Louisiana Energy Services, LLC
NRC Docket No. 70-3103

Subject: Semi-Annual Safety Analysis Report (SAR) Update

Enclosure 1
Marked up pages SAR revision 51b

Enclosure 3
Marked up pages SAR revision 51d

Figure 1.1-8 Separations Building Module 1001 UF₆ Handling Area Equipment Location

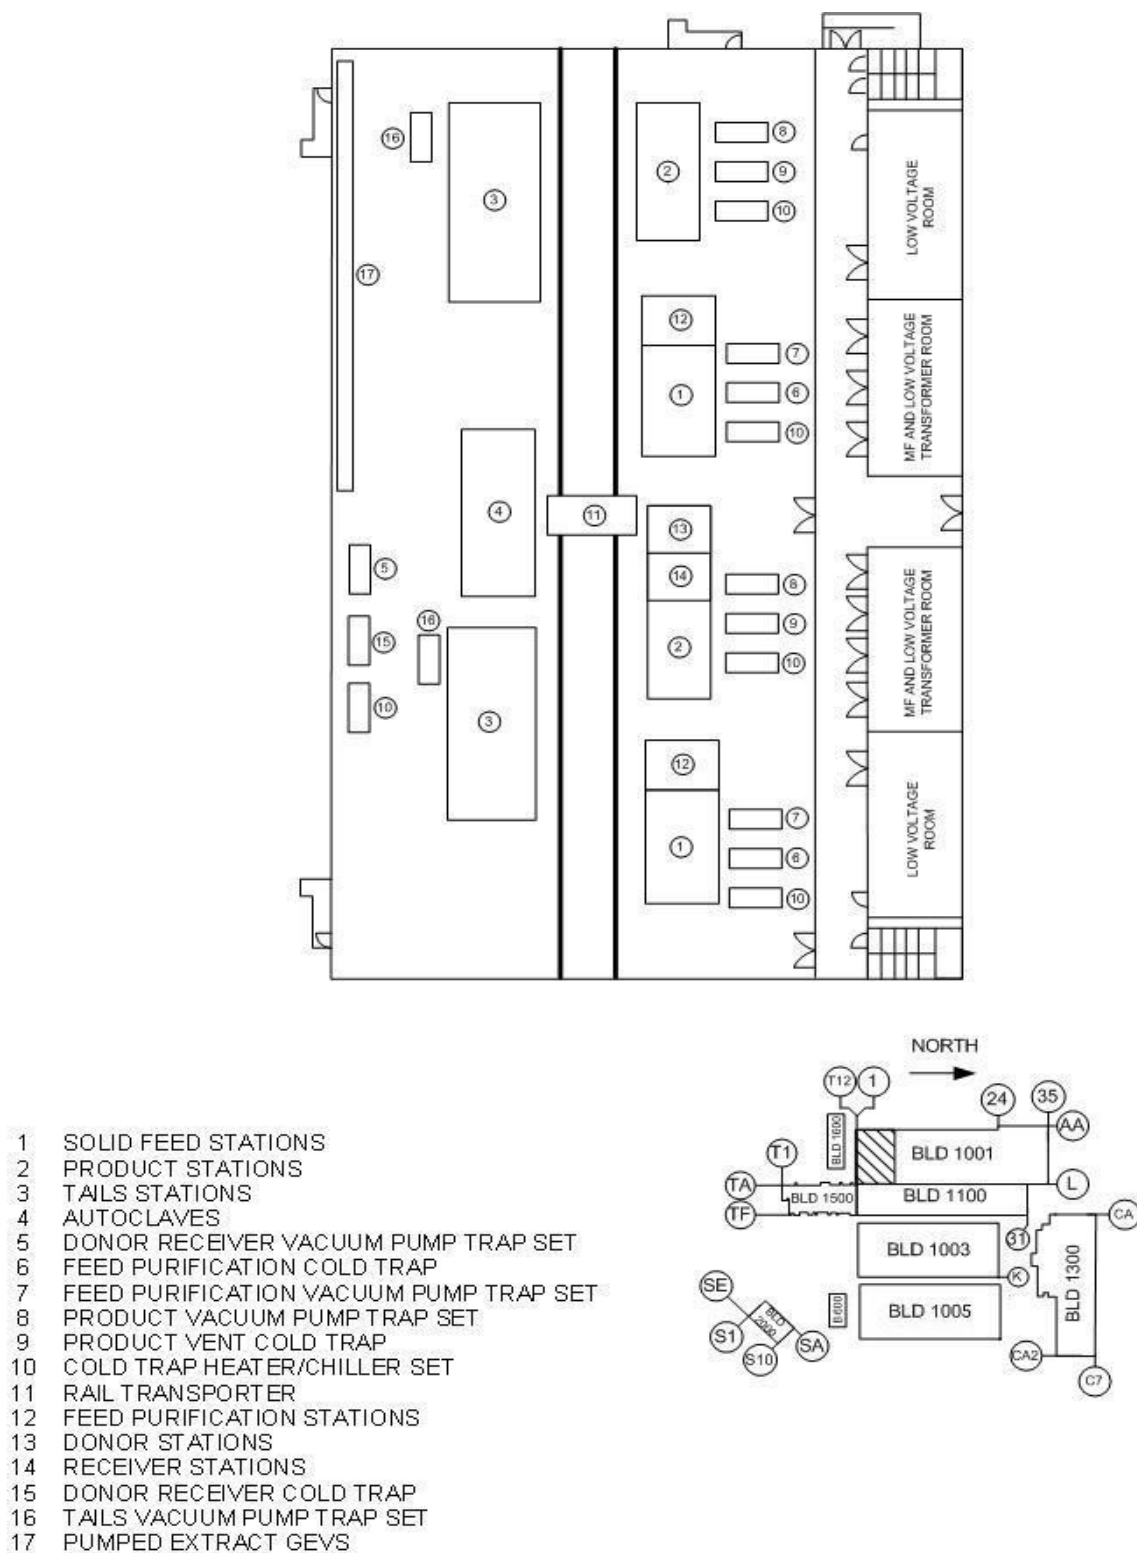
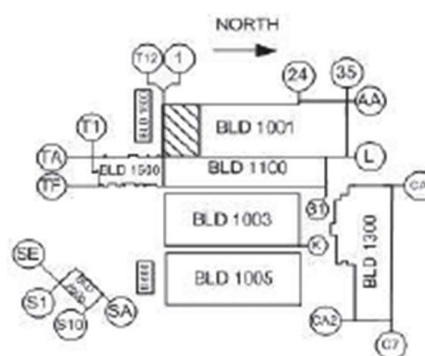
Summary of Changes Rev ~~51d~~ 54e		
Issue / Date	Change	Description of Change
51d /	LBDCR-25-001	GCP-154: Removal of reference to “Medical Room”. Changing language, specifically as it pertains to the requirement to qualify 29 CFR 1910.120 (q)(6)(ii), First Responder Operations Level.
	LBDCR-24-016	MOD-24-0039: New cabinets for the storage of 1S and A1 bottles in the SBMs and CRDB, Figures 1.1-8, 1.1-17, and 1.1-20.

- 1 SOLID FEED STATIONS
- 2 PRODUCT STATIONS
- 3 TAILS STATIONS
- 4 AUTOCLAVES
- 5 DONOR RECEIVER VACUUM PUMP TRAP SET
- 6 FEED PURIFICATION COLD TRAP
- 7 FEED PURIFICATION VACUUM PUMP TRAP SET
- 8 PRODUCT VACUUM PUMP TRAP SET
- 9 PRODUCT VENT COLD TRAP
- 10 COLD TRAP HEATER/CHILLER SET
- 11 RAIL TRANSPORTER
- 12 FEED PURIFICATION STATIONS
- 13 DONOR STATIONS
- 14 RECEIVER STATIONS
- 15 DONOR RECEIVER COLD TRAP
- 16 TAILS VACUUM PUMP TRAP SET
- 17 PUMPED EXTRACT GEYS
- 18 **UF6 Sample Storage Lockers/Cabinets**

Figure 1.1-20 Separations Building Module 1005 UF6 Handling Area Equipment Location

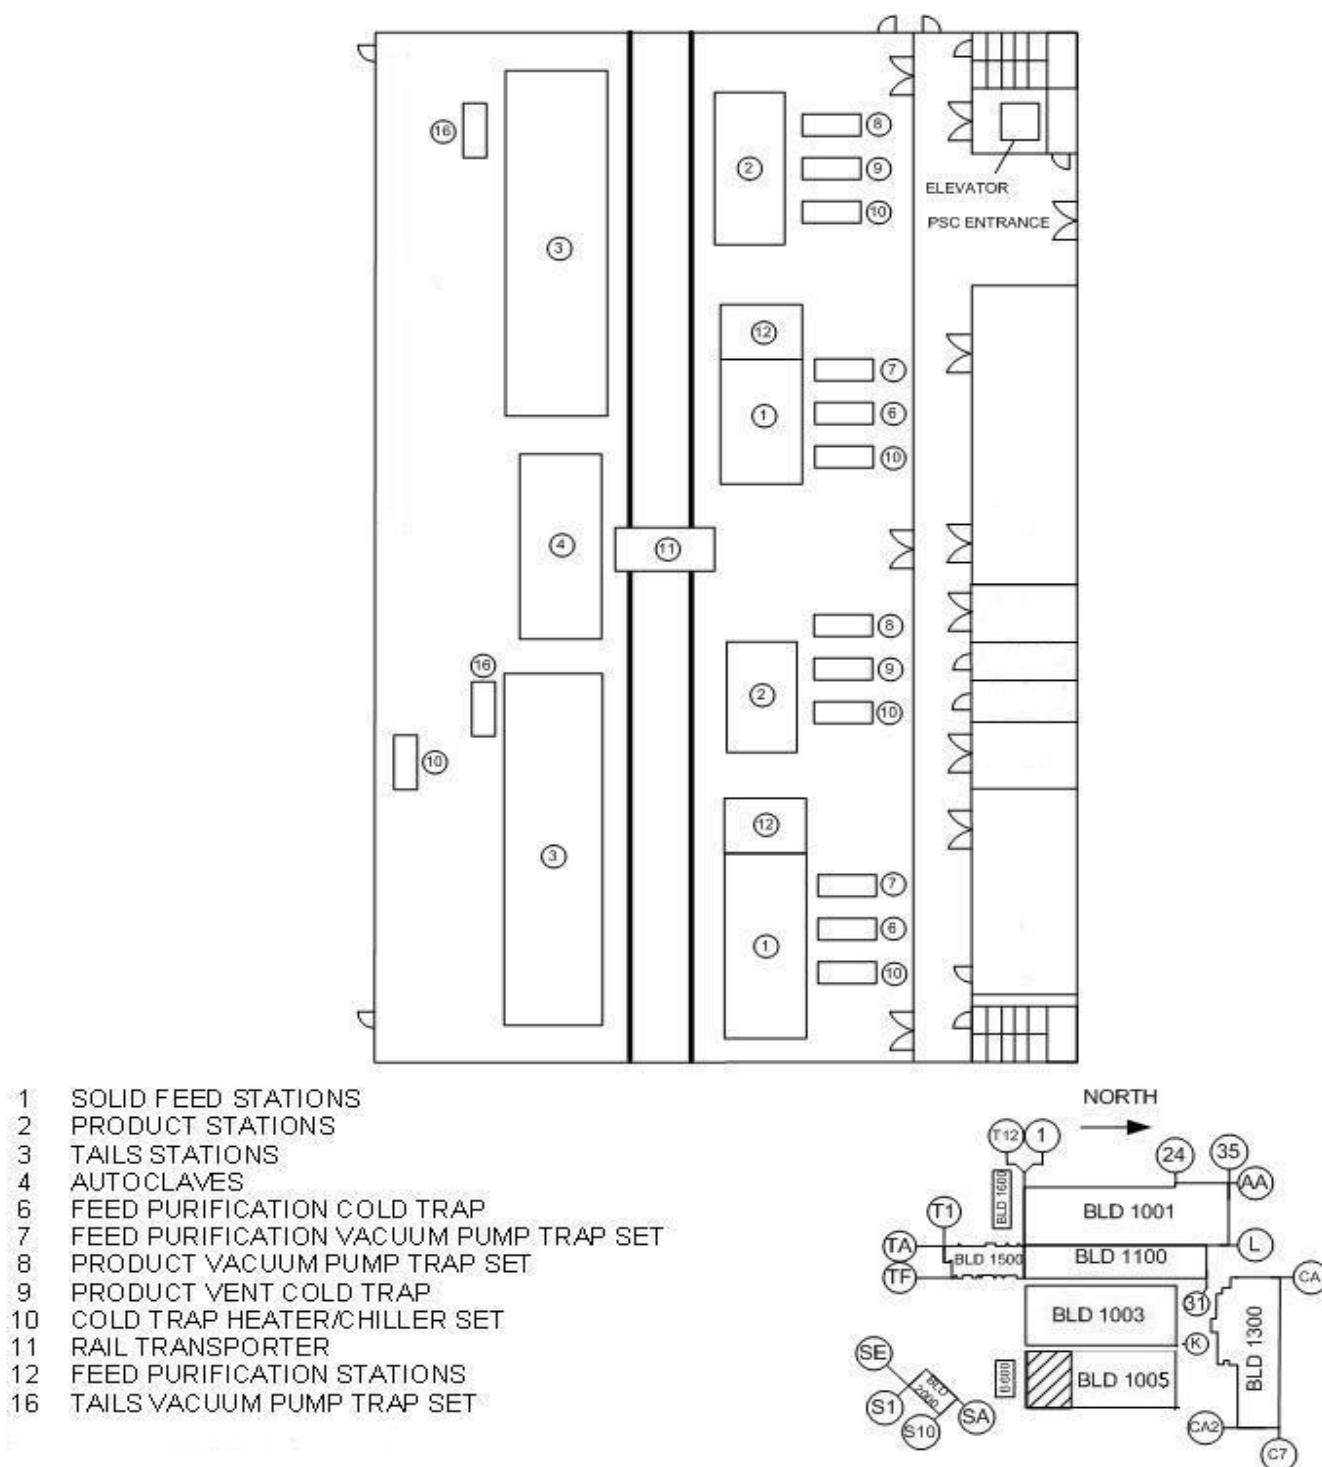
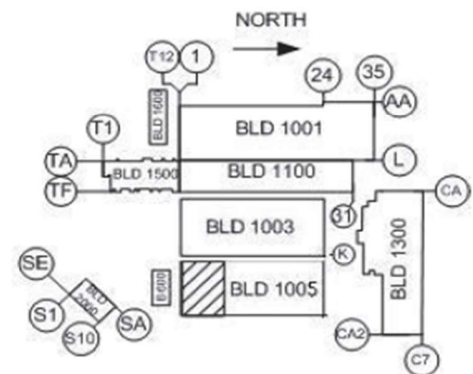
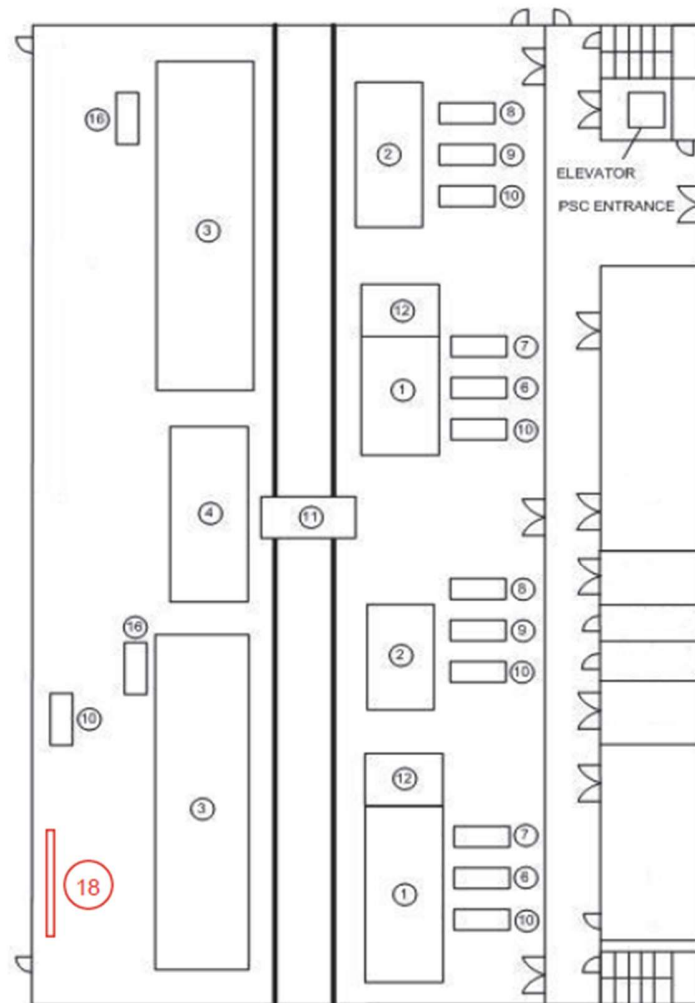
- 1 SOLID FEED STATIONS
- 2 PRODUCT STATIONS
- 3 TAILS STATIONS
- 4 AUTOCLAVES
- 6 FEED PURIFICATION COLD TRAP
- 7 FEED PURIFICATION VACUUM PUMP TRAP SET
- 8 PRODUCT VACUUM PUMP TRAP SET
- 9 PRODUCT VENT COLD TRAP
- 10 COLD TRAP HEATER/CHILLER SET
- 11 RAIL TRANSPORTER
- 12 FEED PURIFICATION STATIONS
- 16 TAILS VACUUM PUMP TRAP SET
- 18 UF6 Sample Storage Lockers/Cabinets
